Date: March 15, 2018  
To: Cumberland Planning Board  
From: Carla Nixon, Town Planner  
Subject: OceanView at Cumberland - Major Subdivision Preliminary Plan Review

Date March 15, 2018  
To Town of Cumberland Planning Board  
From Carla Nixon, Town Planner  
Subject **Major (Preliminary) Subdivision Review: Oceanview @ Cumberland. 277 Tuttle Road**

As requested, Sevee & Maher Engineers, Inc. (SME) has completed a review of the comment responses submitted for the preliminary application for a Major Subdivision and Site Plan for the proposed OceanView at Cumberland senior living community located off Tuttle Road. This submission is identified by the applicant as Revised Preliminary Subdivision Plan Submittal – Addenda-1A. The application materials received by SME were prepared by LICHT Environmental Design, LLC (LICHT), and consist of the following:

FIELD WK:	SCALE:	SHEET:
DRN BY:	JOB #: 109	C21
CH'D BY:	SS:	
DATE: 3-1-2018	FILE:

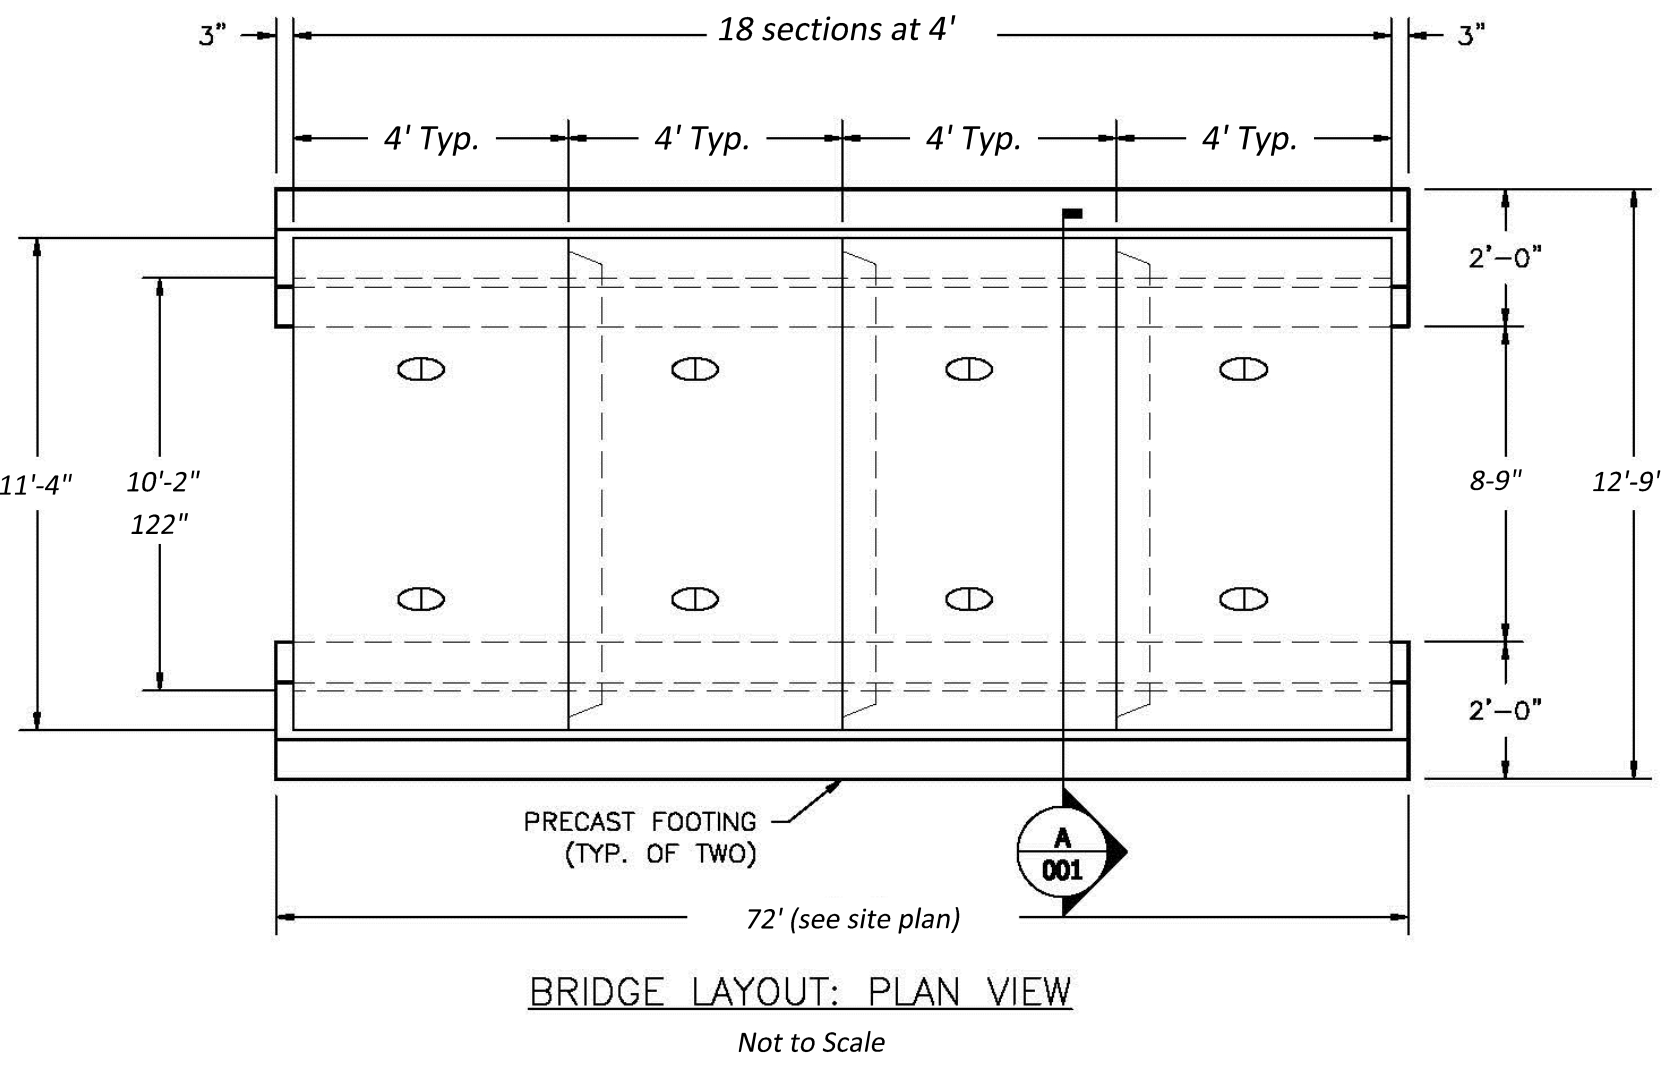
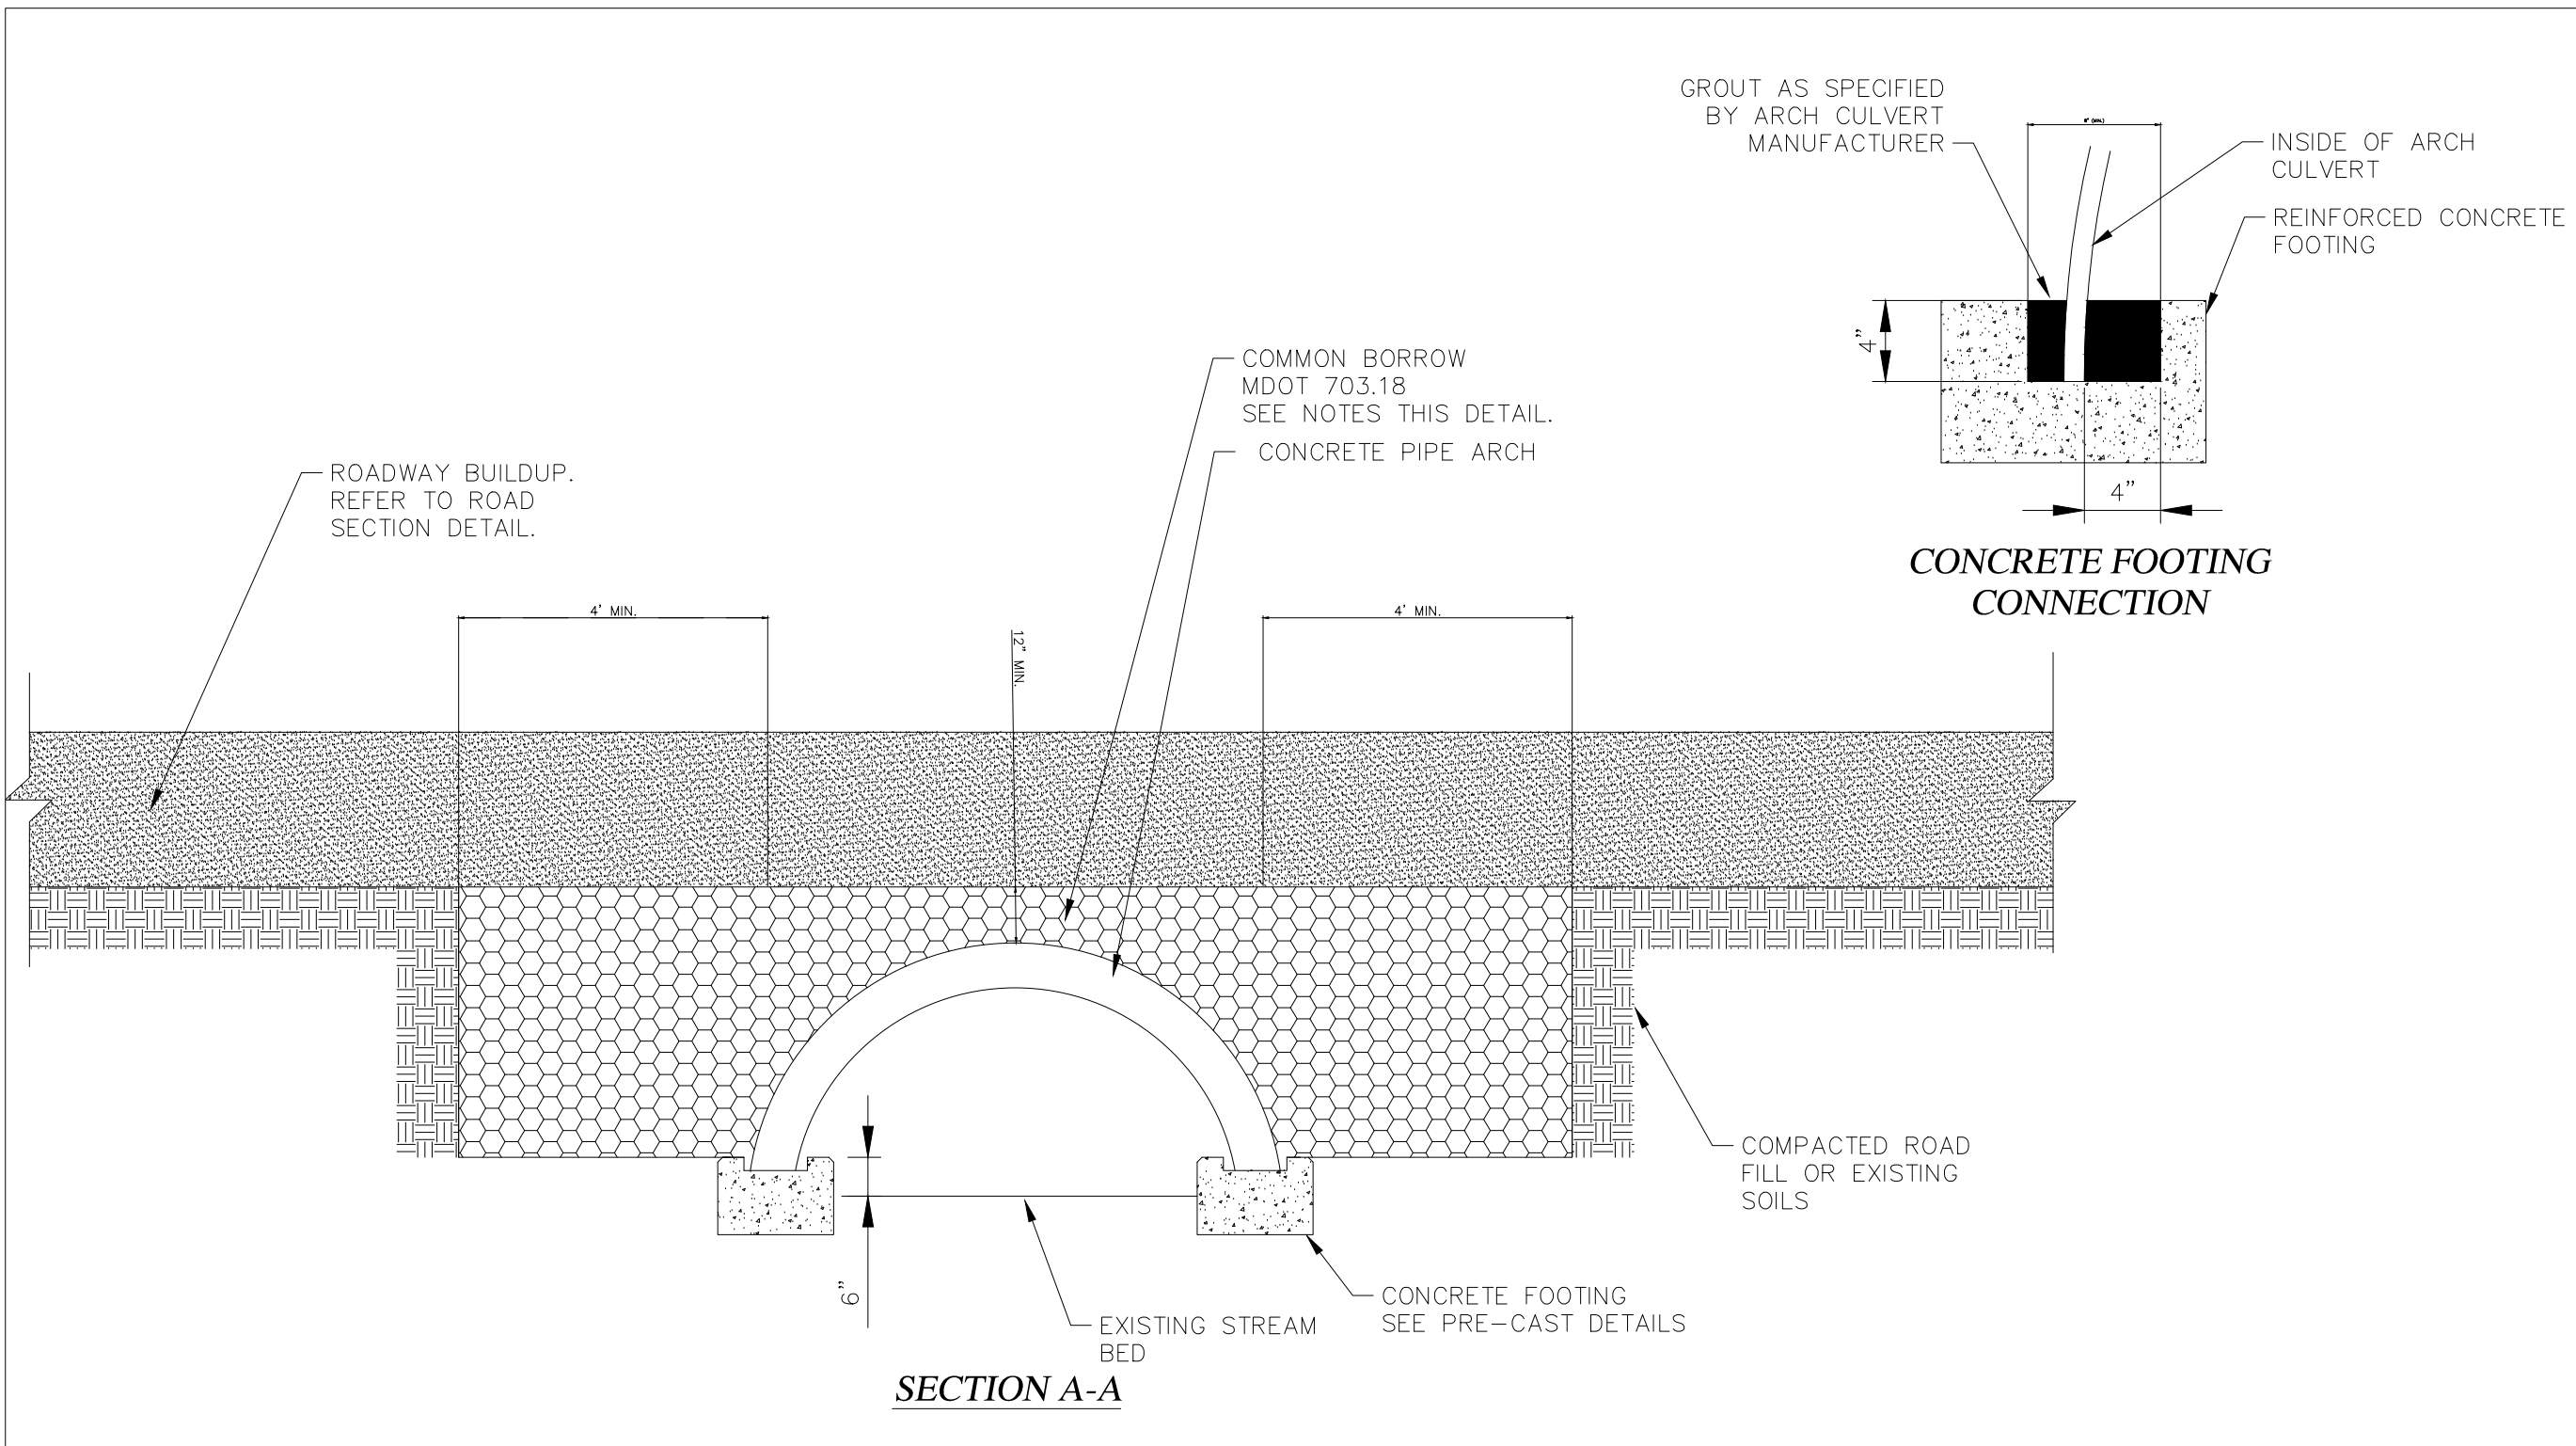
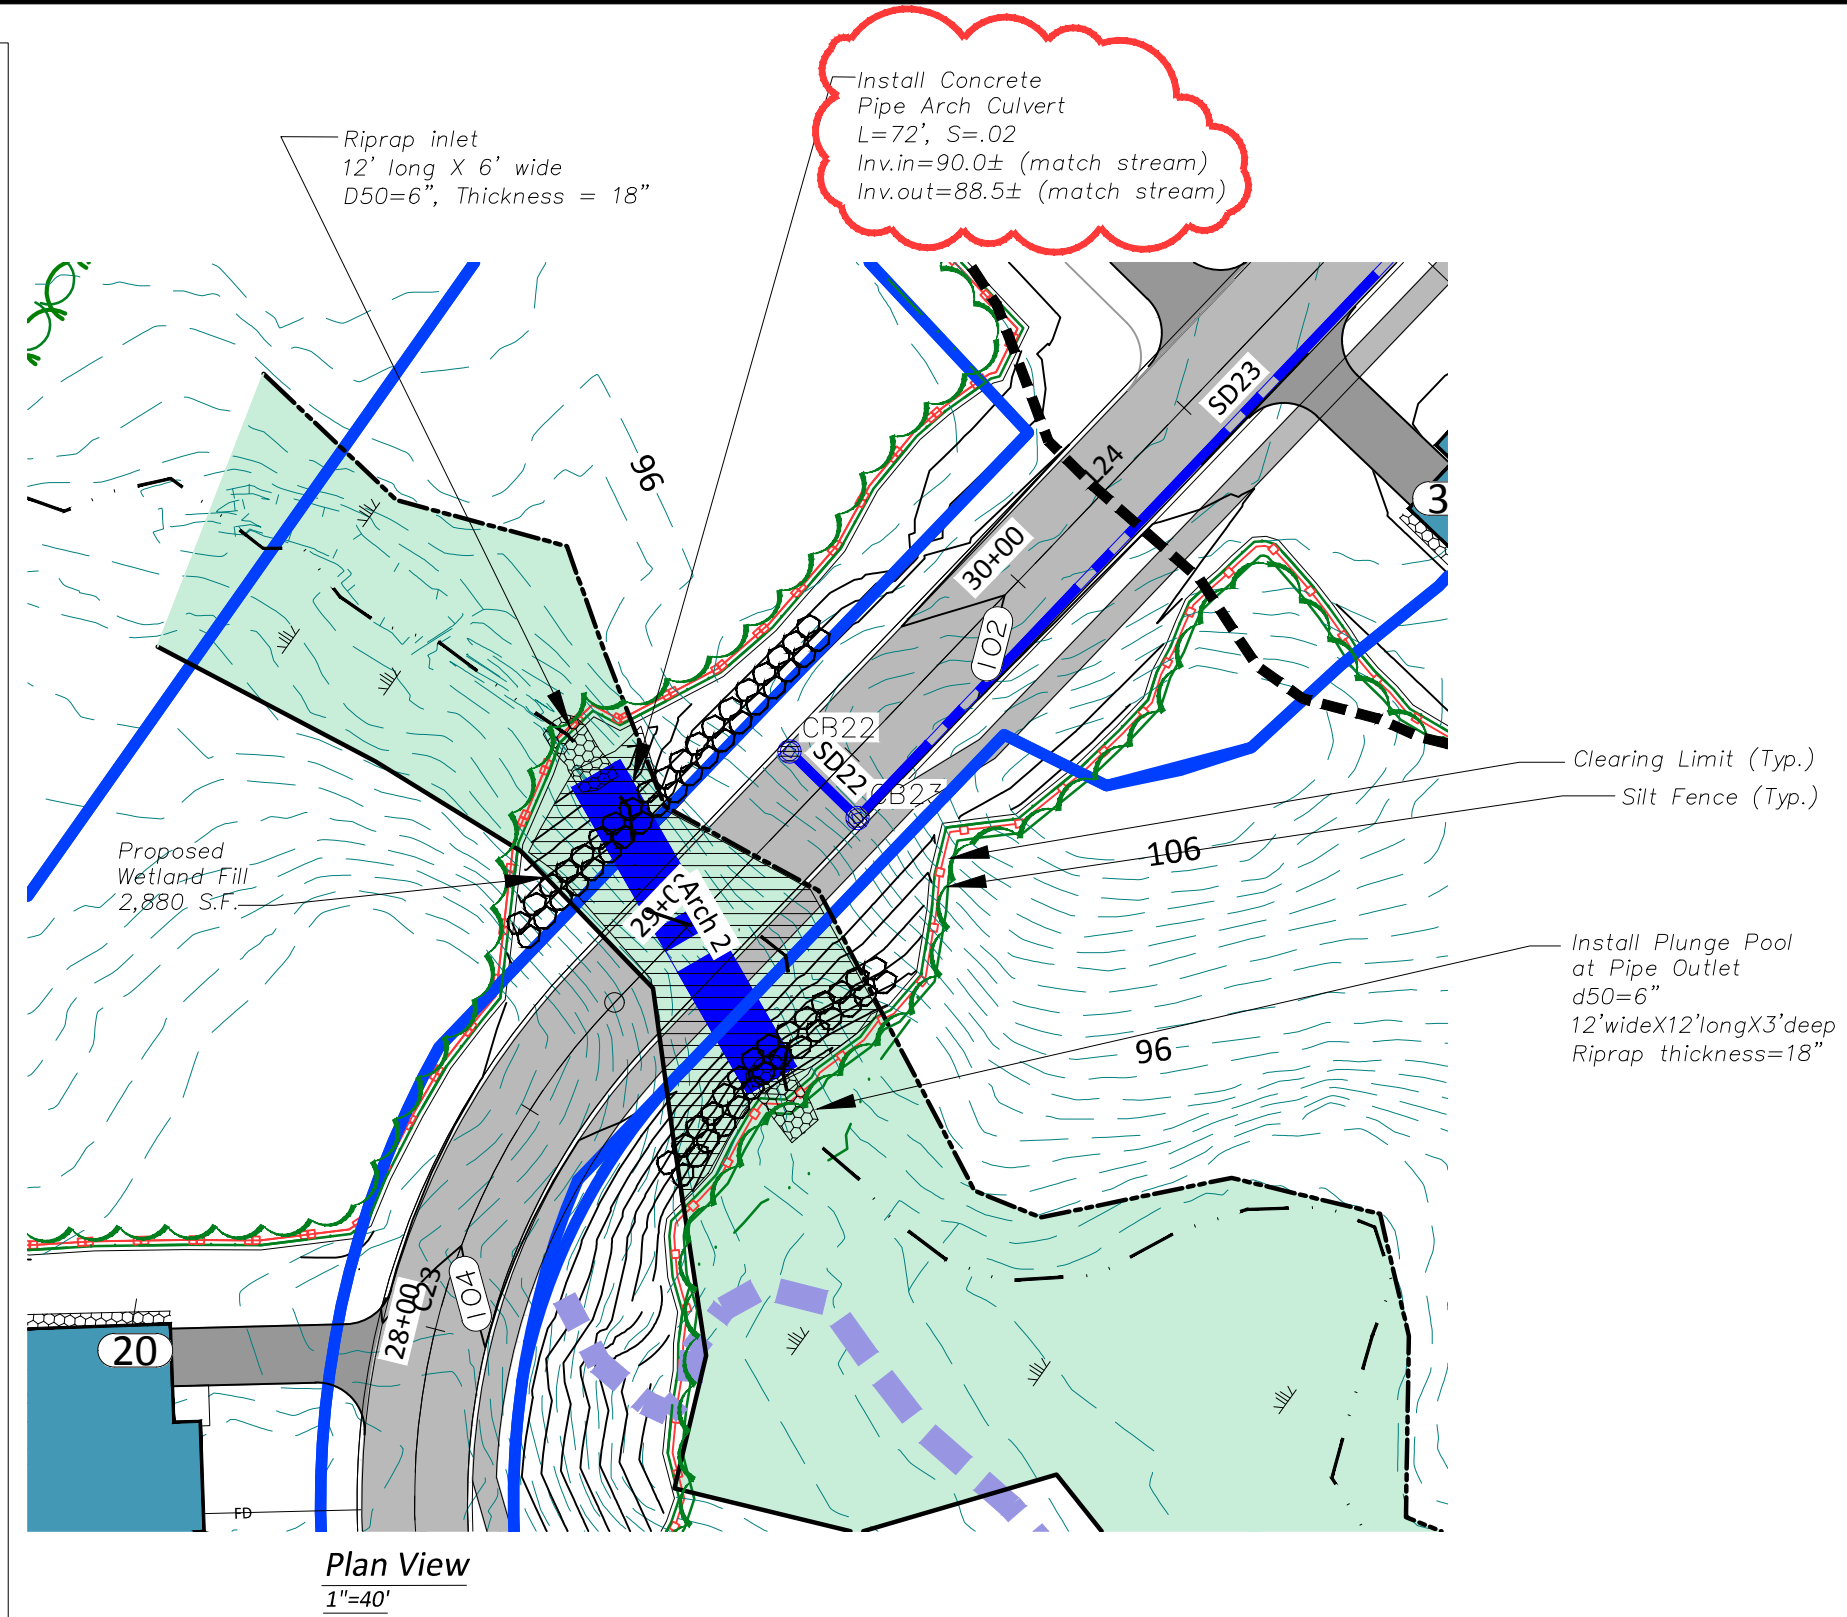
39. Arch 2 Culvert Details C21 - Profile does not include a sidewalk. SME recommends the applicant update the plan to reflect proposed construction.

39. Arch 2 Culvert Details C21 - Profile does not include a sidewalk. SME recommends the applicant update the plan to reflect proposed construction. *The culvert details and sizing have been revised (100 year storm design). It should be noted that final construction details will be provided for final plan submittal pending agency reviews.*
